BRUNSWICK STATION

**MAJOR DEVELOPMENT REVIEW APPLICATION
WAREHOUSE / OFFICE DEVELOPMENT
104 HARPSWELL ROAD, BRUNSWICK, MAINE
TAX MAP U36, LOT 33**

Re: Response to Review Engineer Comments
WAREHOUSE / OFFICE DEVELOPMENT
104 HARPSWELL ROAD, BRUNSWICK, MAINE

| TITLE: | | GRADING PLAN |

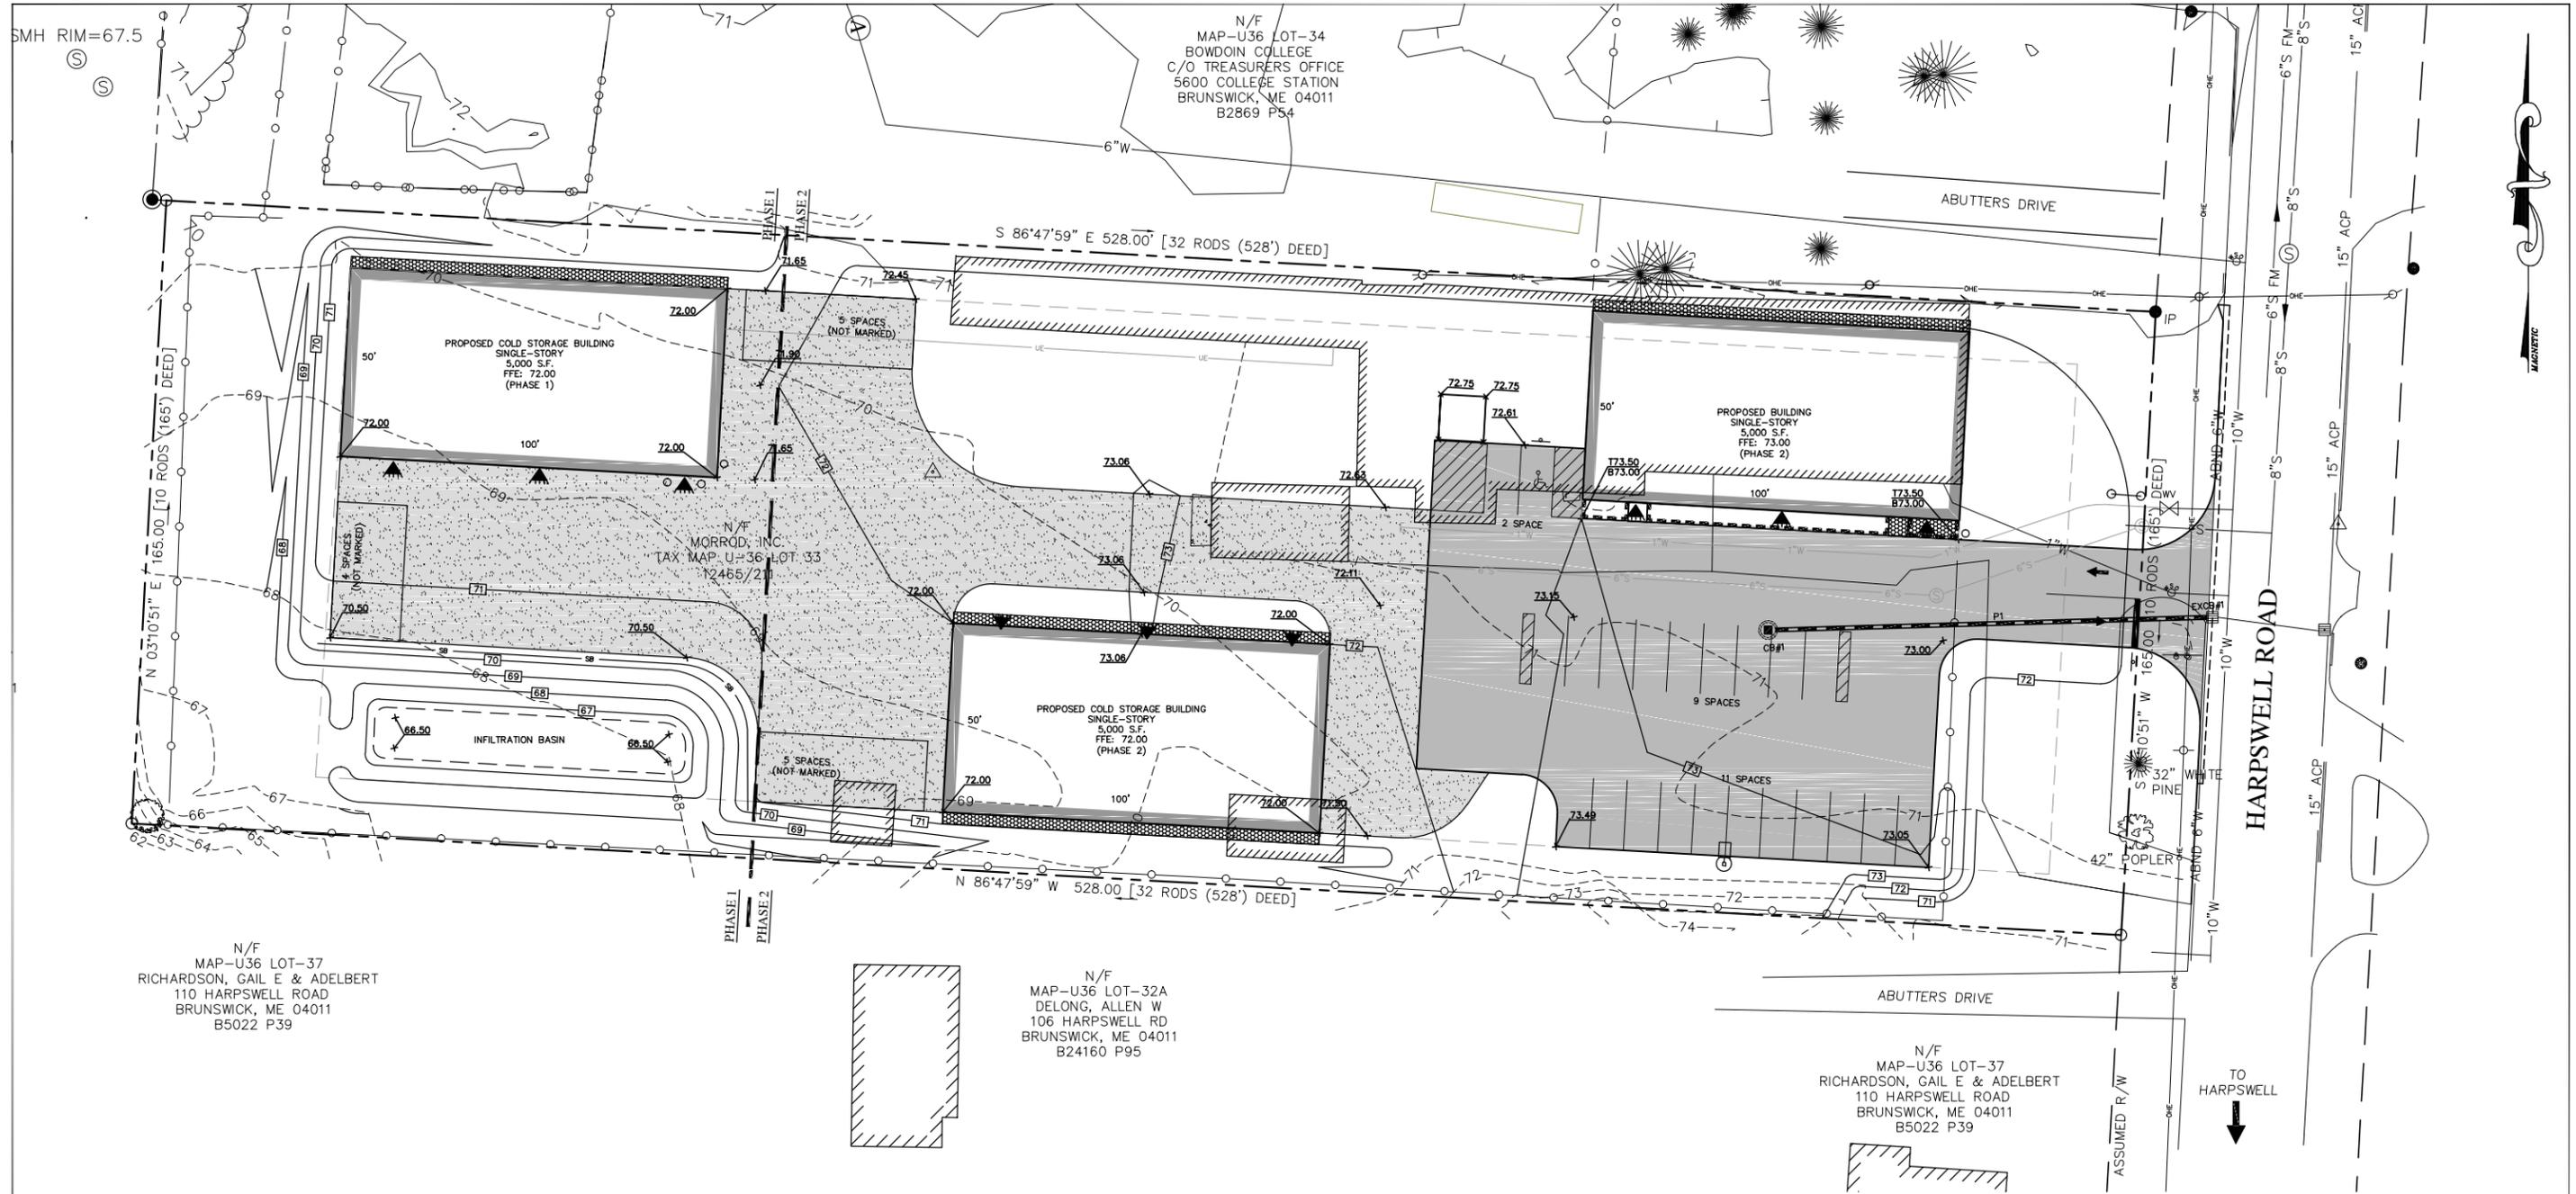
7. The grading plan needs to show silt fence around the pond to keep sediment and impede flows from directly entering the basin until there is a substantial grass catch on the side slope.

8. Snow Storage areas should not be allowed in the infiltration pond bottom, and are likely not going to occur along the front of the site, due to landscaping being planted in front of the building. Please reflect areas where storage can be allowed, and it may be beneficial to add a note that if necessary the snow removal may be contracted to be removed if excessive or creates safety concerns on site.

Sediment control has been added to the grading plan protect the basin as suggested.

Snow storage areas are shown on the plan. The landscaping in front is set back sufficient to allow for removal from the entrance drive. A note has been added indicating snow shall not be stored on the infiltration basin.

| FIELD WK: MC | SCALE: N/A | SHEET: C3 |

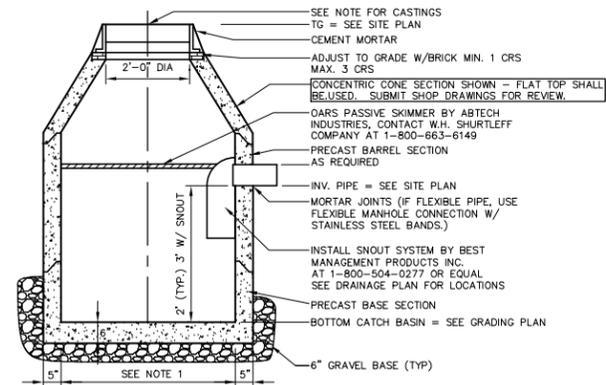
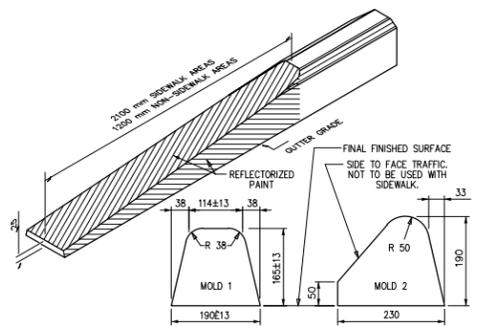
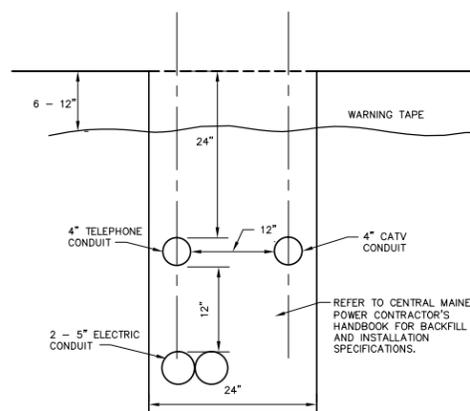
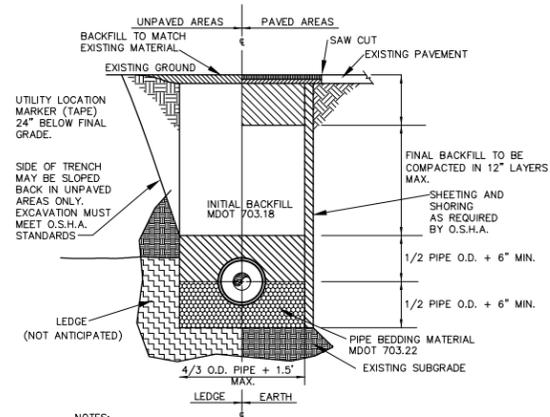
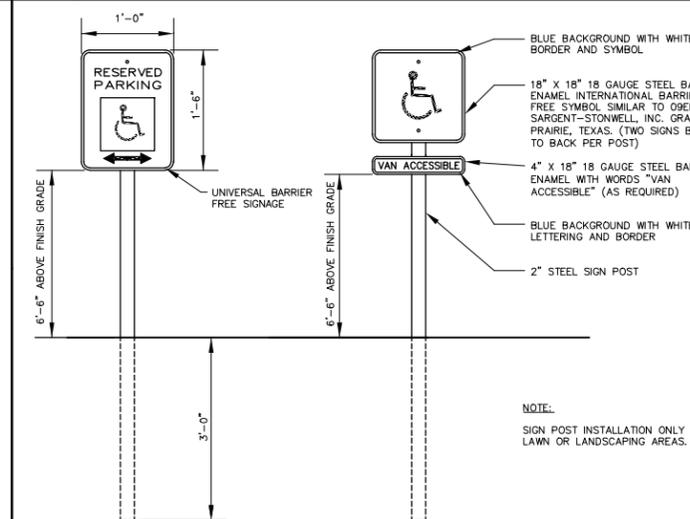
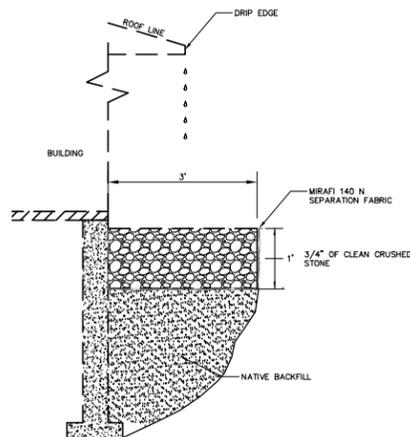
12. Lastly many construction details are missing from the plan set. See below details we would typically request for review:

- a. *Catch basin detail with sump.* On Sheet C3
- b. *Pipe trench detail.* On Sheet C3
- c. *Pavement cross section.* On Sheet C3
- d. *Gravel section (note compaction needed)* On Sheet C3
- e. *Roof drip-edge x-section.* On Sheet C3
- f. *Wheel stops or curbing edge.* On Sheet C3
- g. *Infiltration pond cross section and spillway.* On Sheet C4
- h. *Stabilized entrance.* On Sheet C5
- i. *Forebay for pond.* Not Added
- j. *Grass swales.* On Sheet C4

Most of the details were include on Sheet C3. Those related to the pond are added to new Sheet C4.

C4

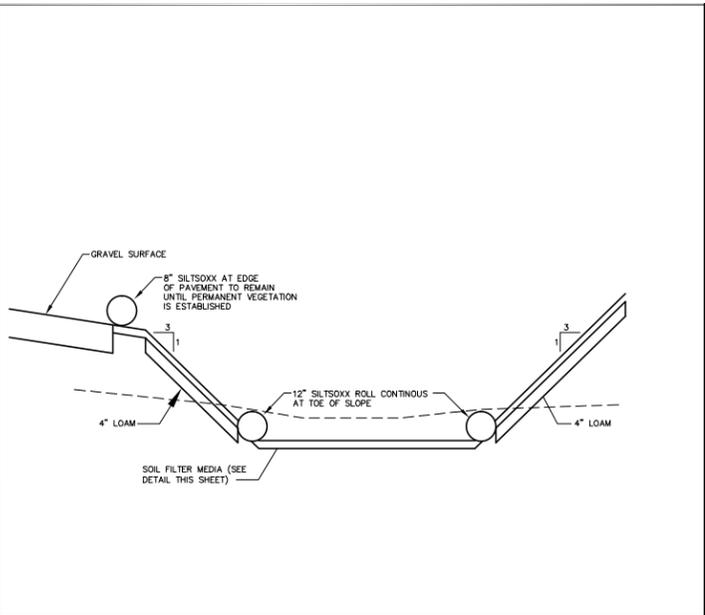
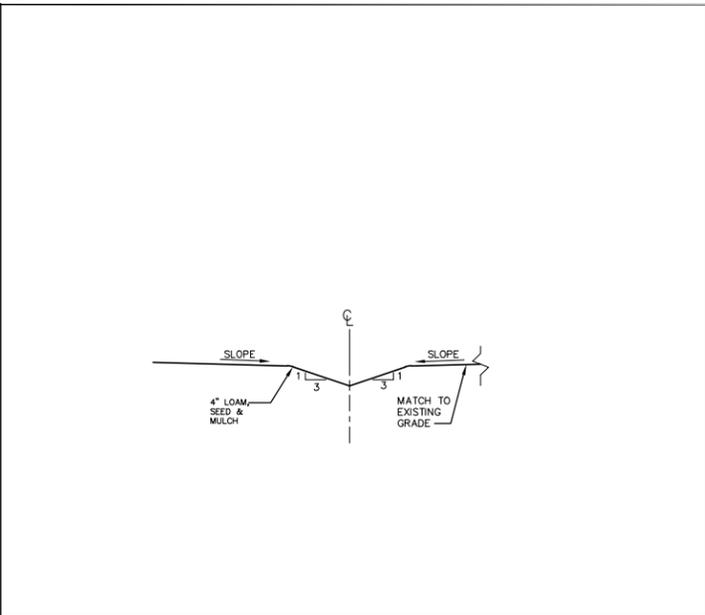
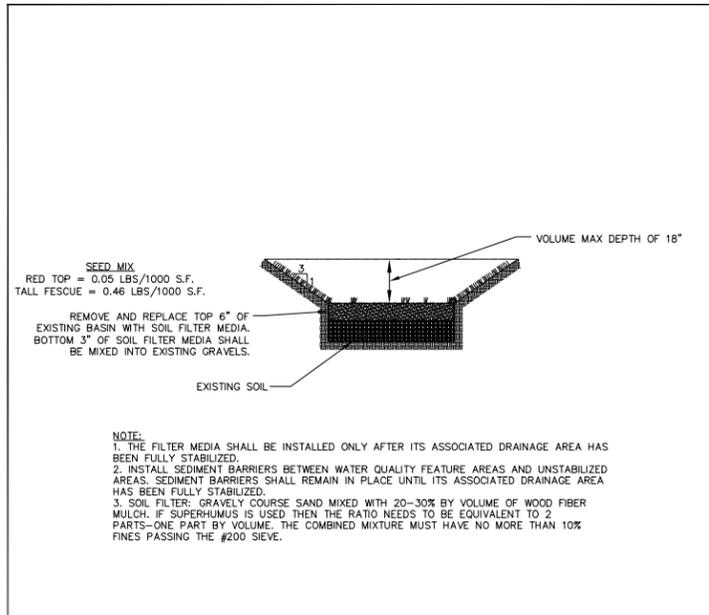
c. The engineer needs to provide a cross section detail of the pond, and the spillway.

A pond cross section detail has been added to the set. Details will be provided.
